THE METROPOLITAN WATER DISTRICT  
OF SOUTHERN CALIFORNIA

Notice of Availability of the  
Draft Environmental Impact Report for the World Logistics Center Project

The Metropolitan Water District of Southern California (Metropolitan) has received the Notice of Availability of the Draft Environmental Impact Report (EIR) for the World Logistics Center Project (proposed project). The proposed project covers 3,918 acres in eastern Moreno Valley, generally located east of Redlands Boulevard, south of State Route 60 (SR60), west of Gilman Springs Road, and north of the San Jacinto Wildlife Area. The project proposes a maximum of 41.4 million square feet of high-cube logistics warehouse distribution uses classified as "Logistics Development" and 200,000 square feet of warehousing-related uses classified as "Light Logistics." Also included in the proposed project is a General Plan Amendment that will designate 2,635 acres for logistics development, 20 acres for public utility uses, and 1,159 acres for permanent open space. The remaining 104 acres will be used for utility extensions to serve the proposed project. Within the proposed project area, 2,710 acres are included in a proposed World

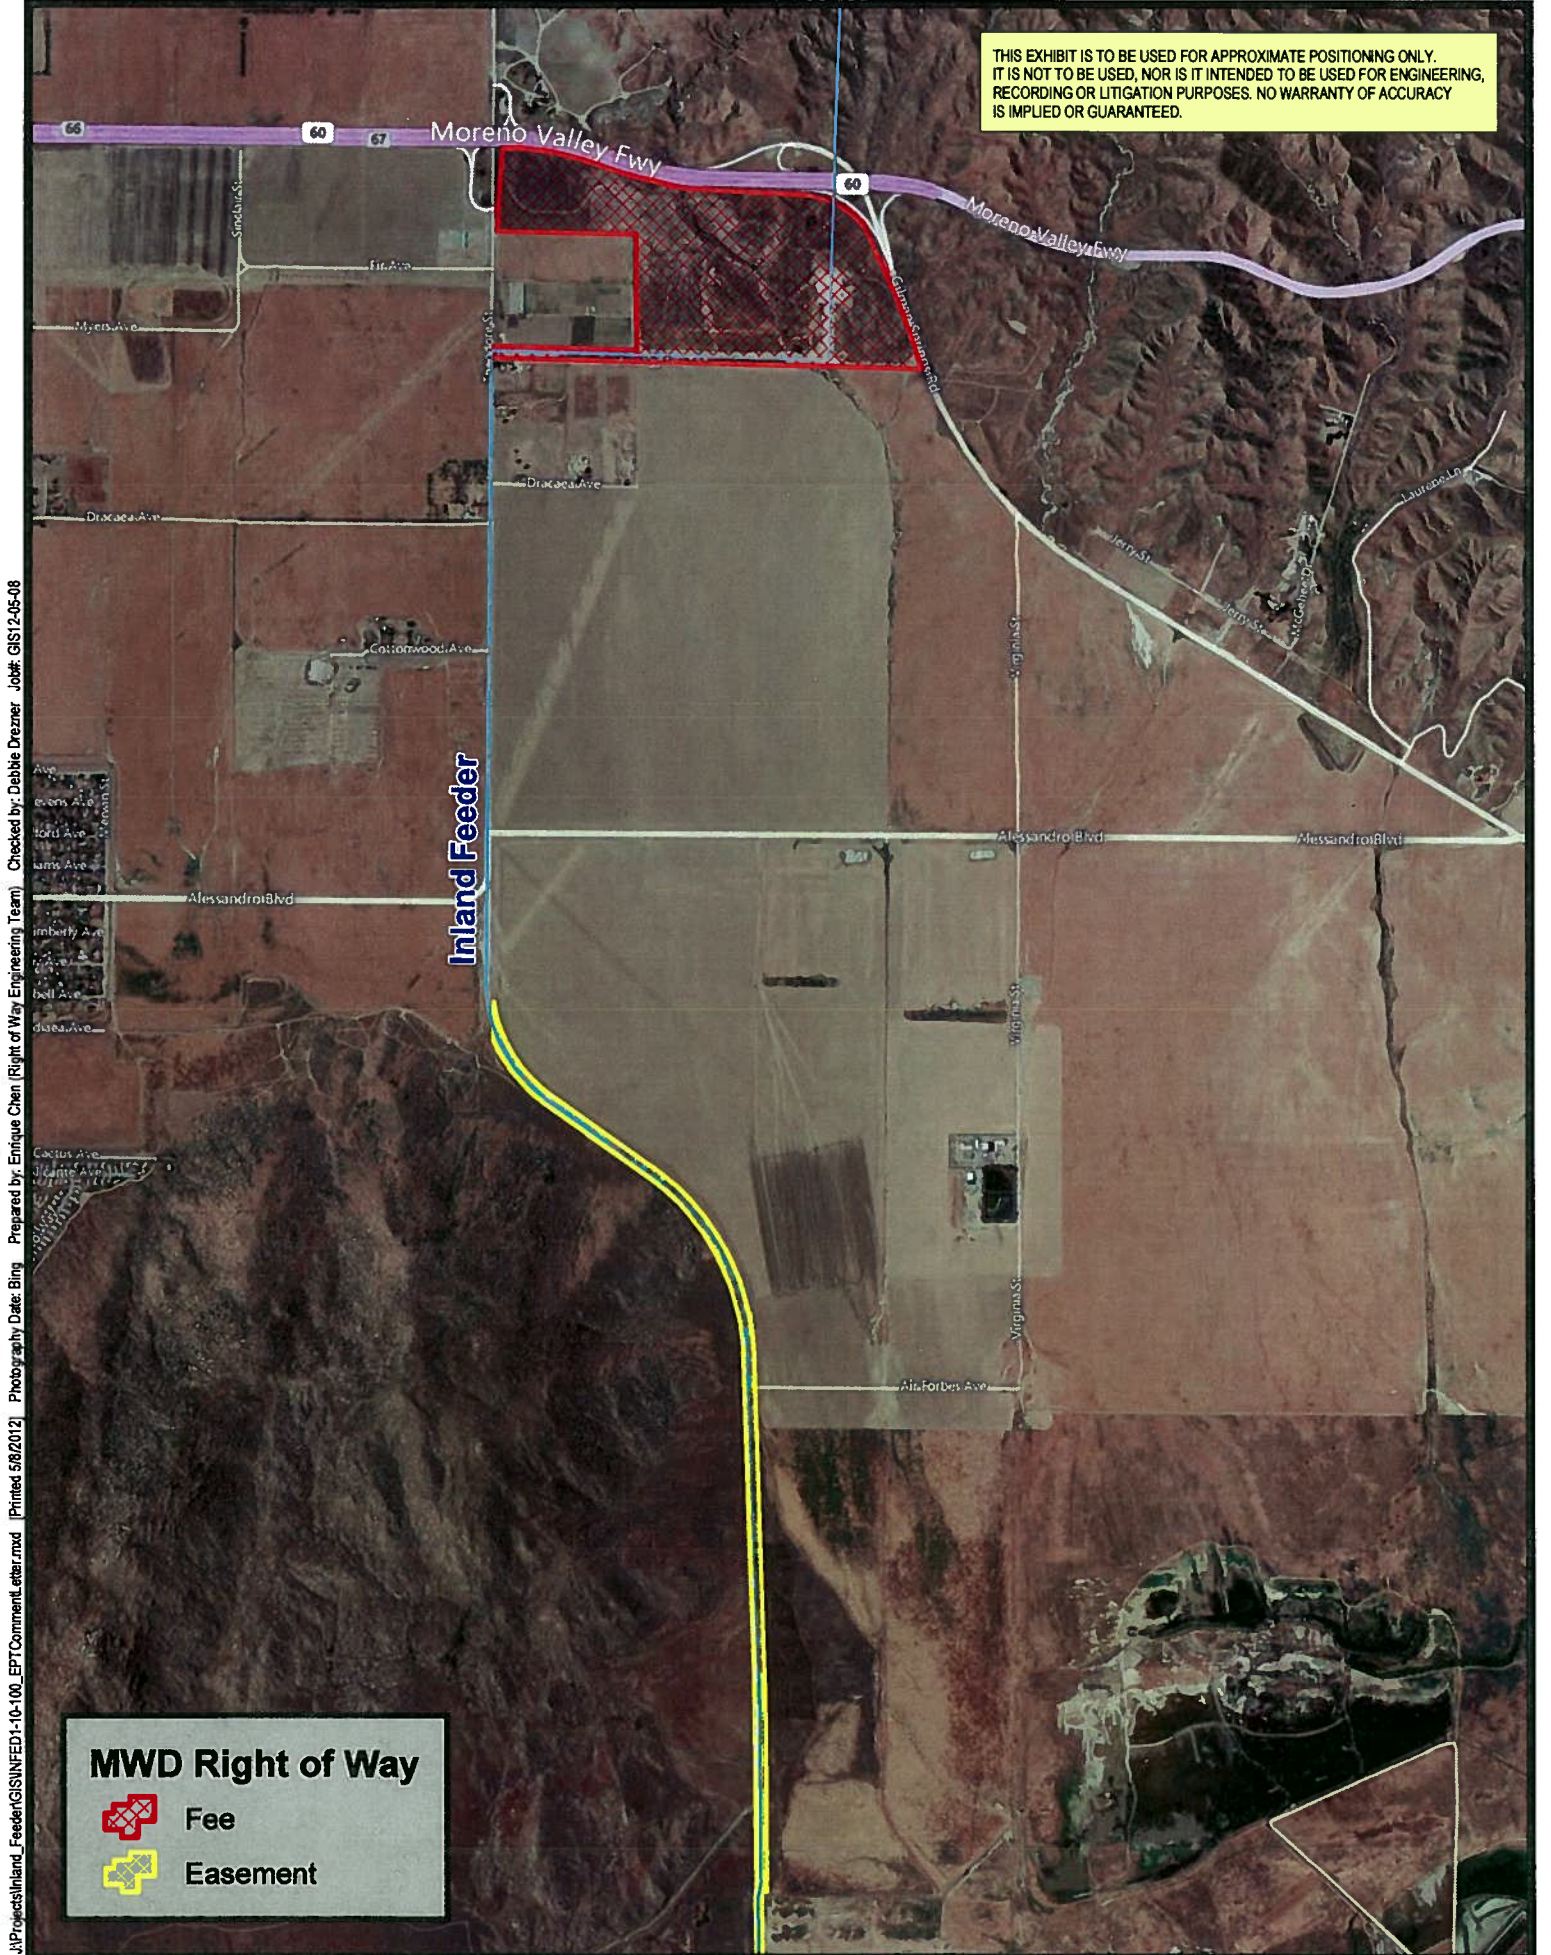
Metropolitan owns property and owns and operates facilities on and adjacent to the site of the proposed project. As shown on the attached map, Metropolitan's irregularly shaped fee-owned property (APN 422-040-009 and 422-040-015), Inland Feeder Tunnel, and appurtenant tunnel access structure are located within the proposed specific plan area. In addition, Metropolitan's 145-inch-inside-diameter Inland Feeder pipeline and appurtenant structures extend through the specific plan area in the street rights-of-way for Eucalyptus Avenue, Theodore Street, and Davis

Road. Metropolitan also has a 110-foot-wide easement along Davis Road. While Metropolitan's property is referenced in Sections 3.3.1 and Section 4.4.1 of the Draft EIR, the Inland Feeder pipeline is not mentioned in the document.

Metropolitan is concerned with the potential impacts to its fee property, the Inland Feeder pipeline, and associated facilities resulting from future excavation, construction, utilities or any development that may occur as a result of proposed project activities. Please note that Metropolitan does not allow any structures within its fee property or easement. Development associated with the proposed project must not restrict any of Metropolitan's day-to-day operations and/or access to its facilities. Metropolitan must be allowed to maintain its rights-of-way and requires unobstructed access to its facilities and properties at all times in order to repair and maintain its system. Detailed prints of drawings of Metropolitan's pipelines and rights-of-way may be obtained by calling Metropolitan's Substructures Information Line at (213) 217-6564. To assist in preparing plans that are compatible with Metropolitan's facilities, easements and properties, we have enclosed a copy of the "Guidelines for Developments in the Area of Facilities, Fee Properties, and /or Easements of The Metropolitan Water District of Southern California." Please note that all submitted designs or plans must clearly identify Metropolitan's facilities and rights-of-way.

In order to avoid potential conflicts with Metropolitan's facilities and rights-of-way, Metropolitan requires that detailed design plans for any activities within the vicinity of our facilities, fee property or rights-of way be submitted prior to construction for review and written approval. Approval of the proposed project where it could impact Metropolitan's property should be contingent on Metropolitan's approval of design plans for the proposed project. Metropolitan requests that the text of the EIR be revised to acknowledge the presence of the Inland Feeder pipeline and appurtenant facilities within the boundaries of the proposed project and that the text also state that Metropolitan will need to approve any development plans that have the potential to impact Metropolitan's property or facilities.

Additionally, Metropolitan is concerned about limiting other potential uses for its fee-owned property through the proposed specific plan land use designation discussed in the Draft EIR and respectfully requests that its fee-owned property be excluded from this Specific Plan. The property lends itself to not only high cube distribution but to other industrial type uses as well. By allowing more diverse uses, the city can achieve its objective of providing employment opportunities for a wide range of companies and residents as well as enhance the city's tax base by providing a wide variety of employment opportunities for both skilled and semi-skilled workers. In addition, the 500,000 square feet and 24-foot or greater height requirements specified for the logistics development (LD) land use designation (identified in Sections 3.4.2 and 3.4.6 of the Draft EIR) also limits future users of the property. We recommend that the Specific Plan provide adequate flexibility for economically viable uses based on market segmentation dynamics and configuration of developable parcels impacted by topographical and geographical conditions.
